Bristol Water's response to the CMA's Provisional Findings: Index of Appendices

Appendix 3.1 – Bedminster Service Reservoir

Figure 1 Bedminster SR – Leakage in gallons per day

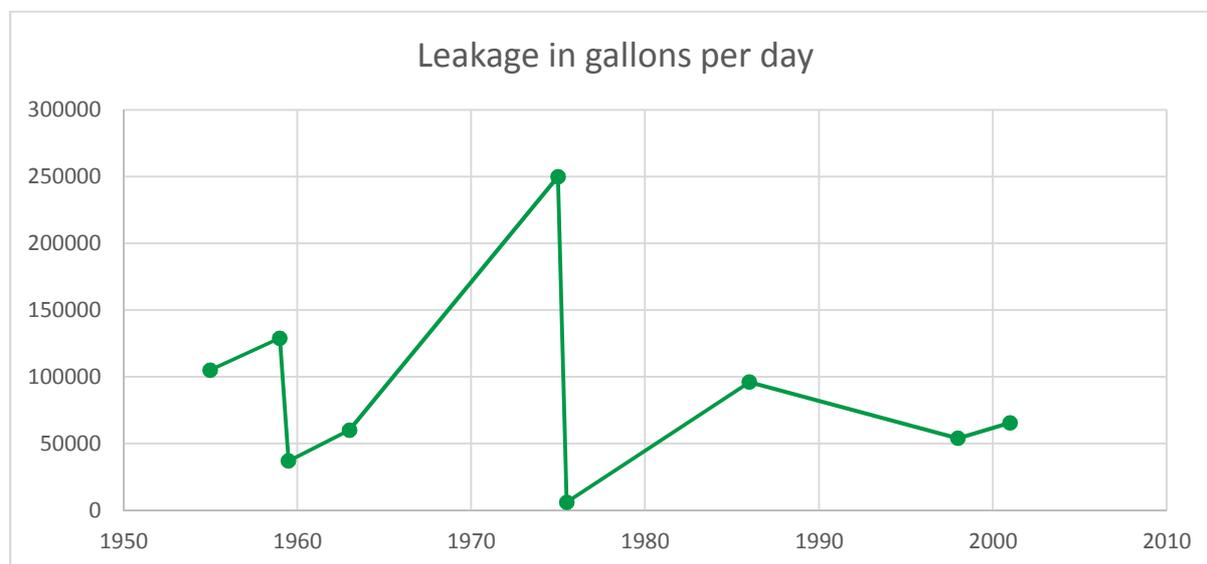
6. As can be seen in Figure 1 below³ leakage has also been a long term issue and whilst repairs have reduced leakage in the short term, leakage slowly increases over time. So much so that prior to 2001 a decision was taken to reduce the operating level of the reservoir to 1.5m below top water level to limit leakage (Refer to P2 - Total Capacity - of the 15/16 May 2001⁴ report that indicates that this decision was taken before 2001).

12. Given that there have been around 15 different repair episodes since 1950 (see **Appendix 3.1.A**), and that leakage from the reservoir has never been successfully addressed (as demonstrated in Figure 1 above) in anything other than the very shortest of terms, it must be concluded that on-going settlement, cracking, leakage, and reduction of water quality is to be expected in an asset of this age.

Figure 2 Cheddar WTW Mean annual phosphorous concentration

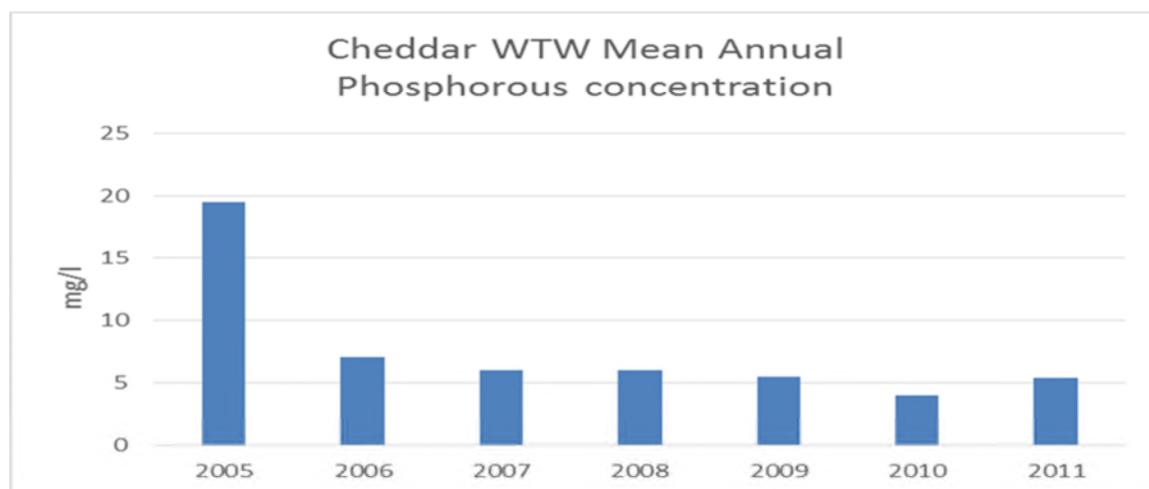
16. Figure 1 below illustrates phosphorus concentration in the raw water.¹⁶⁴ The chart shows that since 2005 the mean concentration of phosphorous has reduced significantly. This reduction coincides with the replacement of stratification equipment in 2006/7. This is likely to be a result of the improved mixing, minimising hypoxia in the lower cooler layers (hypolimnion) of the reservoir. Undisturbed, the hypolimnion provides anaerobic conditions; ideal conditions for release of phosphates from the reservoir sediment and consequentially increased availability to algae which migrate vertically within the body of water.¹⁶⁵
